RE: DOCKET NO. 50-261

CAROLINA POWER & LIGHT COMPANY
H. B. ROBINSON STEAM ELECTRIC PLANT
UNIT No. 2

APPENDIX A

RESPONSE TO STATE AND FEDERAL
AGENCY COMMENTS ON THE
DRAFT ENVIRONMENTAL STATEMENT

Environmental Report
 Supplement No. 1
 H. B. ROBINSON STEAM ELECTRIC PLANT
 UNIT NO. 2
 INTAKE STRUCTURE
 Figure 3.4 a-1a

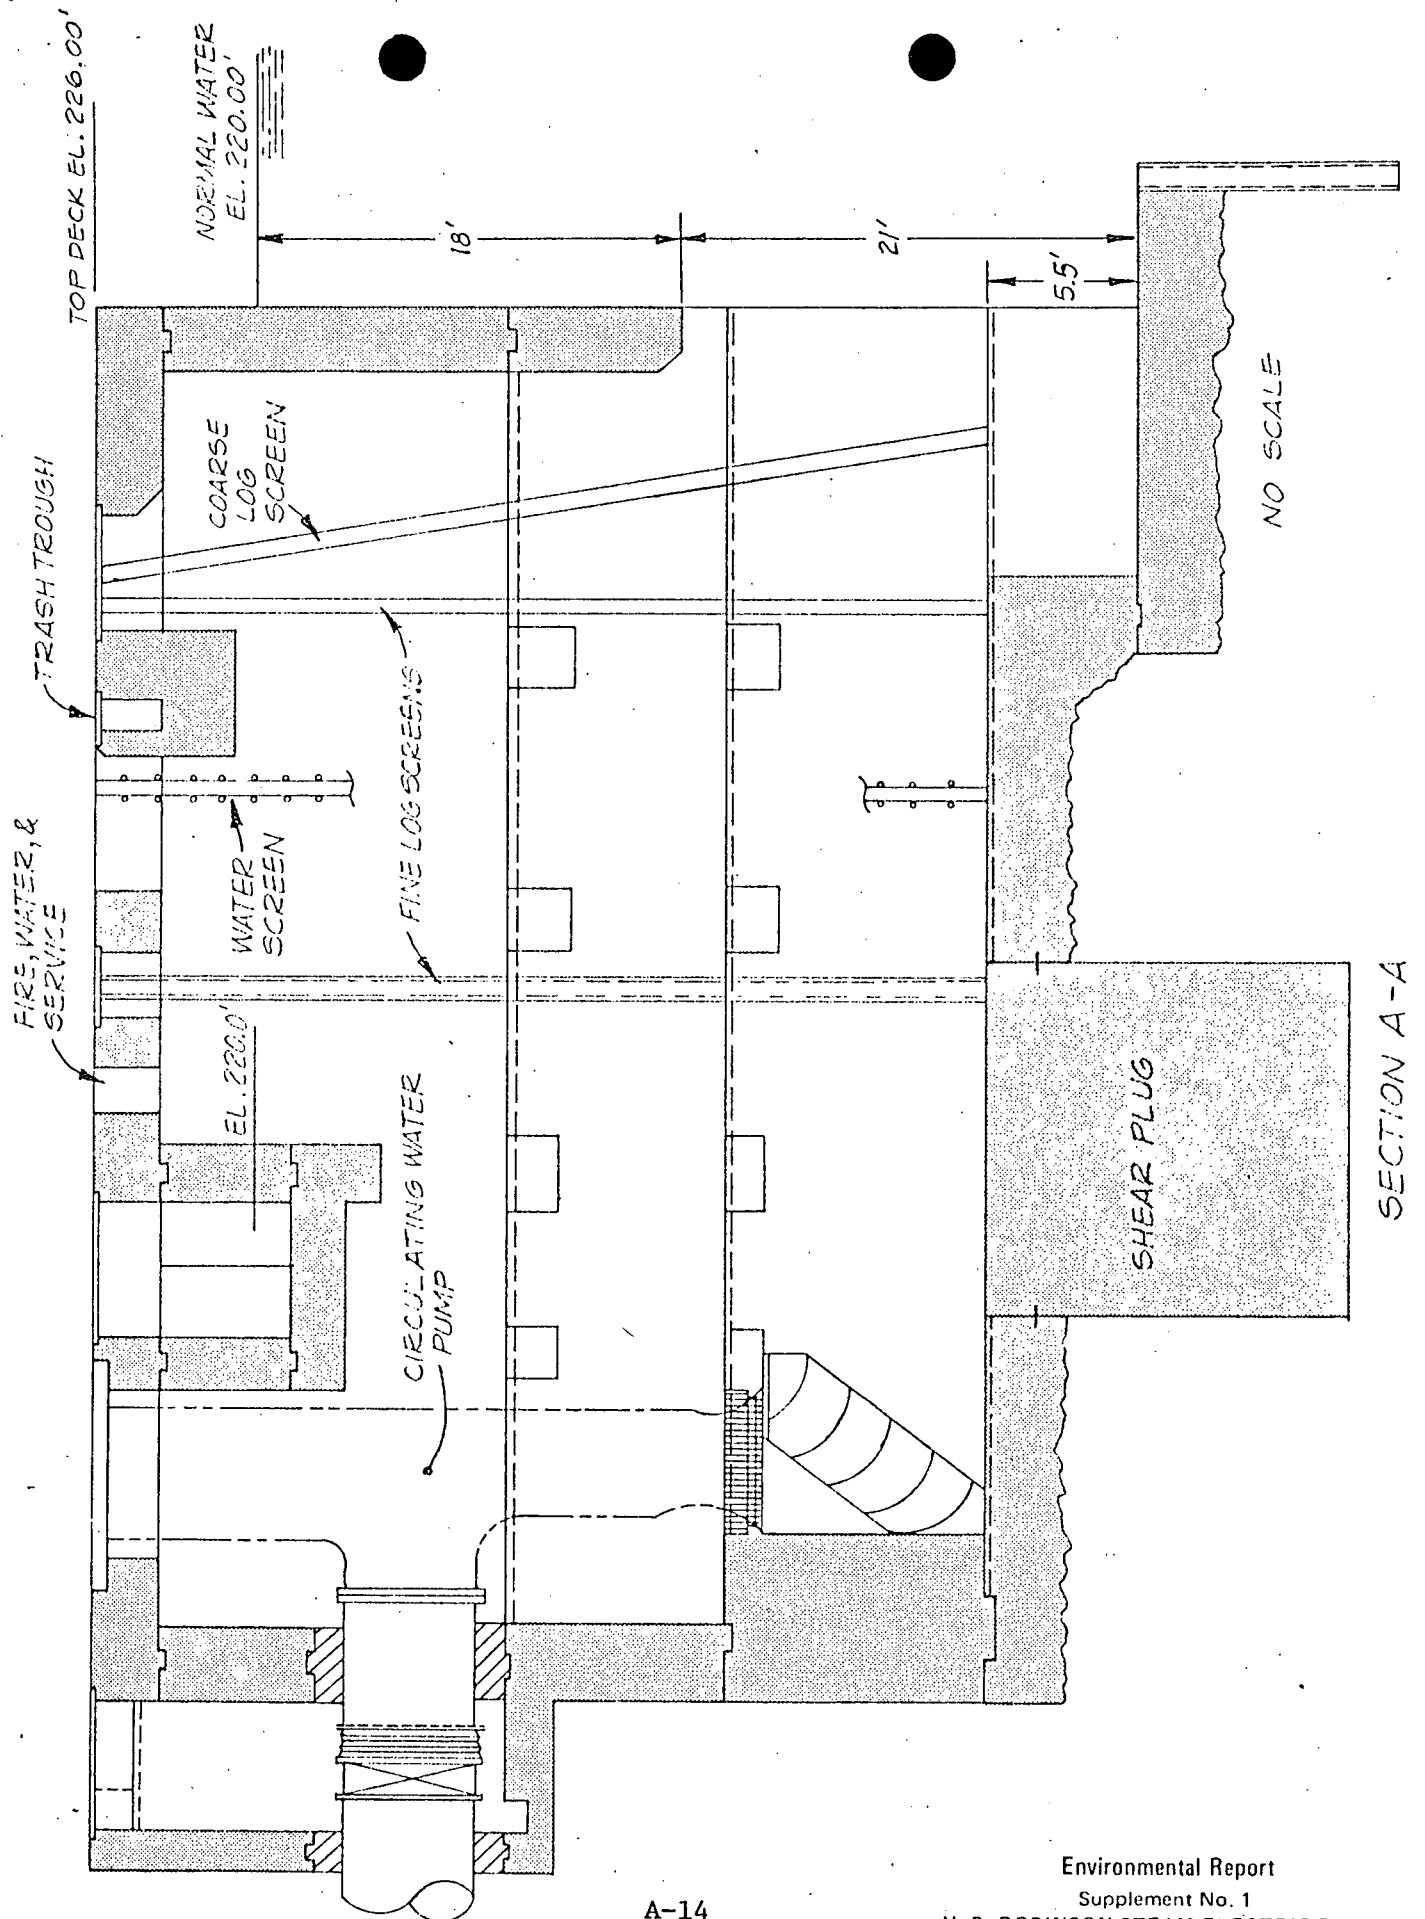
"We suggest that the scale be added to Figure 3.5 to better define the depths from which water is drawn." (Reference 1, page 5)

The revised figure is attached.
